# Service Bulletin

Bulletin No.: 23-NA-147

**Subject:** Squeak Noise from Front Seat

Brand:	Model:	Model Year:		VIN:		Engine:	Transmission:
		from	to	from	to		
Chevrolet	Silverado EV	2024	2024	-	-	All	All

6413677

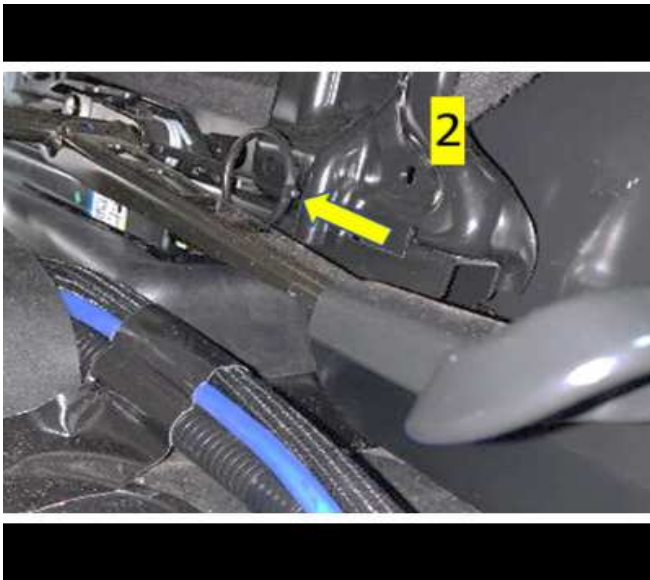
2. Place seat in full FORWARD position and remove rear seat fasteners (1).
3. Move seat to full REAR position and ensure the seat is locked in position by pushing/pulling on the seat cushion or seat back.

6413679

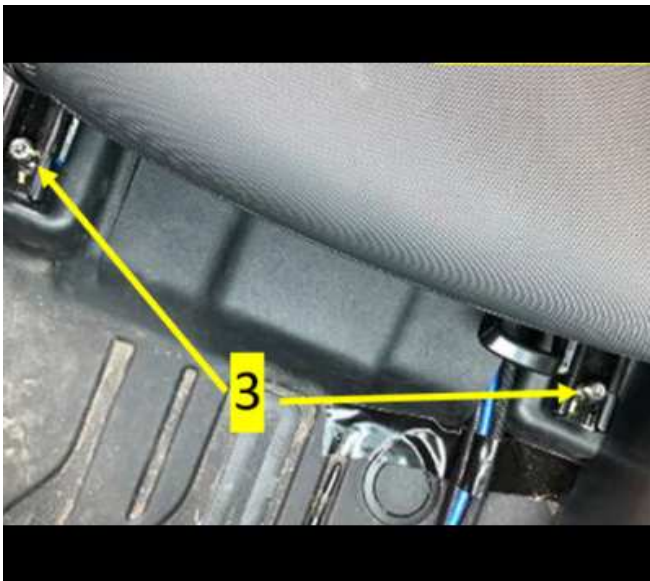
4. Engage the Transport Blocking Feature (2) by pushing the circular pull handle rearward. It will click into place when engaged.

6413680

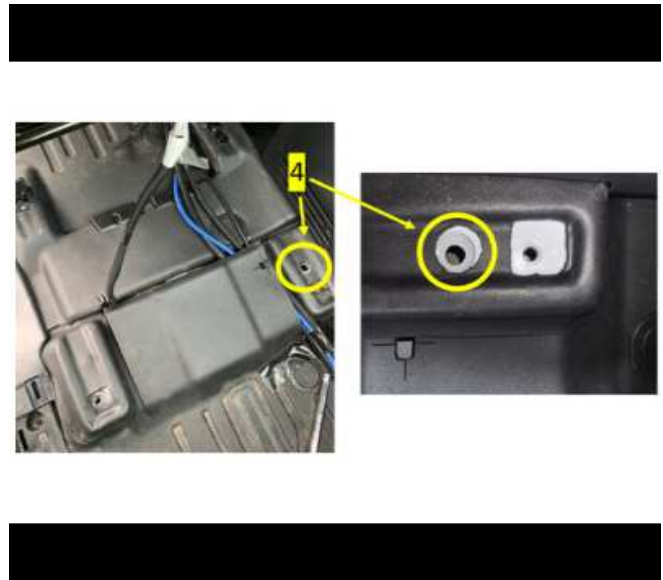
5. Remove the front fasteners (3)

6413681

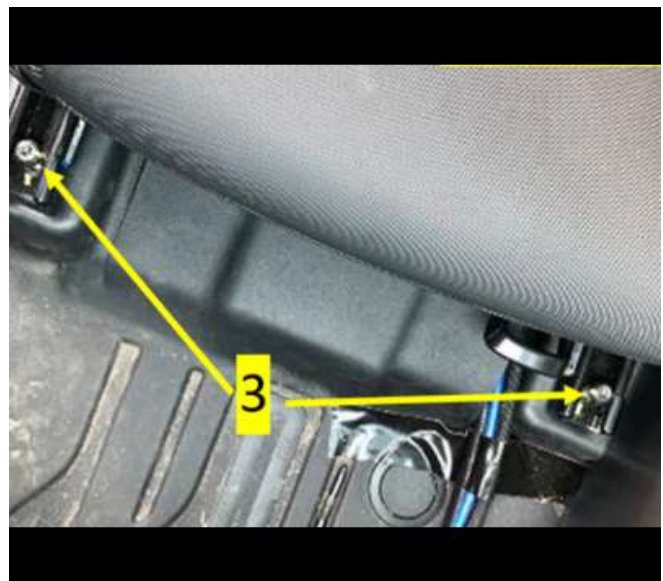
6. Tilt the seat rearward to better access the front inboard seat locator (4). Ensure the vehicle/seat wire harness is not being damaged during this process.
7. Widen the front inboard seat locator to  $\frac{1}{2}$ " (12.7mm) using a step style drill bit.
8. Use a small rounded file, debur the new  $\frac{1}{2}$ " (12.7mm) opening to ensure there are no sharp edges or burrs in the hole.
9. Clean all debris/shavings created by the drilling process

6413680

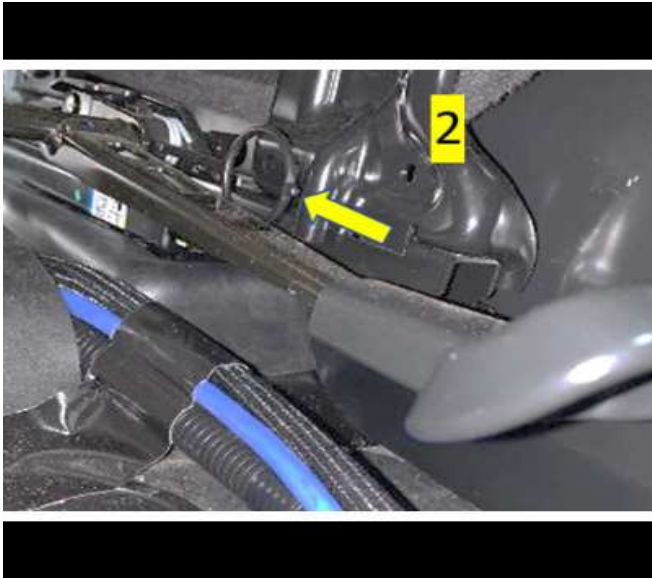
10. Tilt the seat back into position and hand start the front fasteners (3)
11. Torque down the Front Inboard side to (45 Nm +/- 3 Nm)
12. Torque down the Front Outboard side (45 Nm +/- 3Nm)

6413679

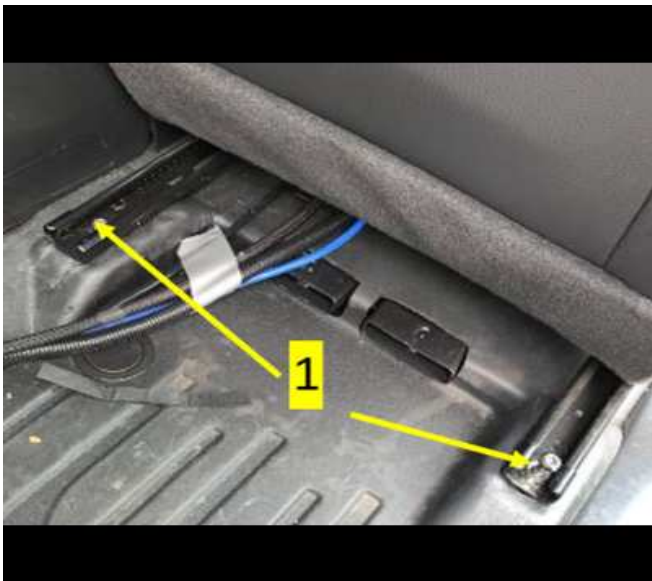
13. Disengage the Transport Blocking Feature (2) by pulling the circular pull handle forward. It will make an audible click when disengaged.
